Staff Report
City of Richmond, Virginia

Commission of Architectural Review

13. COA-164398-2025	Conceptual Review	Meeting Date: 4/22/2025
Applicant/Petitioner	Jean Carlos	
Project Description	Construct a new three-story single-Family home	
Project Location		
Address: 1924 Princess Anne Ave, Richmond, VA 23223		
Historic District: Union Hill		
<p>High-Level Details:</p> <p>The application proposes an infill construction of a new three-and-a-half story single-family dwelling on a vacant parcel located between 1922 and 1926 Princess Anne Street. The proposed structure features full-length front and rear porches, with a second-story front balcony.</p> <p>The design incorporates a mansard roof on the main elevation and a pitched gable roof on the rear elevation, as well as red and tan brick veneer, aluminum-clad windows with cast stone and brick detailing, and Tuscan columns supporting the porch.</p>		
Staff Recommendation	Conceptual Review	
Staff Contact	Yara Iwaz, Yara.Iwaz@RVA.gov, (804)646-6031

1 FRONT ELEVATION
A-2 SCALE: 1/4"=1'-0"

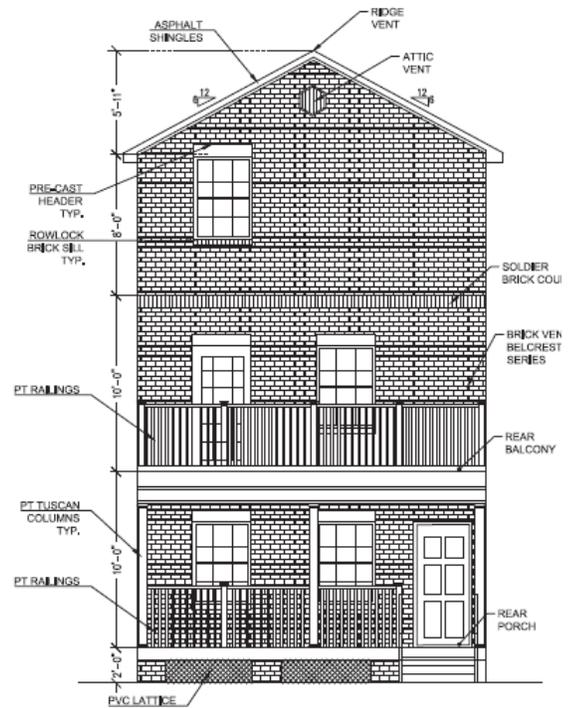
Standards For New Construction: Doors and Windows, p.56	<i>2. The size, proportion and spacing patterns of door and window openings on free-standing new construction should be compatible with patterns established in the district</i>	<p>The proposed south-facing primary façade includes two windows placed closely together near the center of the elevation, appearing as a cluster. This configuration departs significantly from the established fenestration rhythm along Princess Anne Street, where windows are typically evenly spaced across the façade, and framed by a consistent amount of wall surface. Historic dwellings in the district (including those in the Colonial Revival style) exhibit symmetrical, regularly spaced window arrangements, contributing to their balanced appearance.</p> <p>Additionally, as the south-facing façade receives the most sunlight, the design presents a missed opportunity to maximize</p>

<p>light into the interior through a more expansive and evenly distributed window arrangement. The current clustered design emphasizes blank wall space on either side, which disrupts the visual balance expected of buildings in this block.</p> <p><u>Staff Recommends reconfiguring the window placement on the primary façade to reflect the symmetrical and equidistant spacing found on contributing buildings in the district.</u></p> <p>The revised design should provide a more typical window-to-wall ratio, with equidistant openings distributed across the façade and even spacing between openings, appropriate scale relative to the wall area.</p>
<p>Standards for New Construction: Form, page 46</p>	<p><i>3. New residential construction and additions should incorporate human-scale elements such as cornices, porches and front steps into their design. In Richmond, porches were historically an integral part of residential design and provide much of the street-level architectural character of Richmond's historic districts.</i></p>	<p>The Street features a consistent rhythm of human-scaled elements, including transom windows above doors, sidelights, dormers, articulated cornices, and traditional window proportions. These elements contribute to the visual richness and architectural continuity of the street. While the proposed building includes some traditional detailing, such as Tuscan columns and a full-length porch, several typical elements are either missing or not clearly illustrated.</p> <p><u>Staff Recommends including additional historic reference elements, such as transom windows, sidelights and dormers, to align more closely with the streetscape.</u> Drawings should clearly indicate the presence and scale of these features to reinforce contextual compatibility and enhance pedestrian scale.</p>
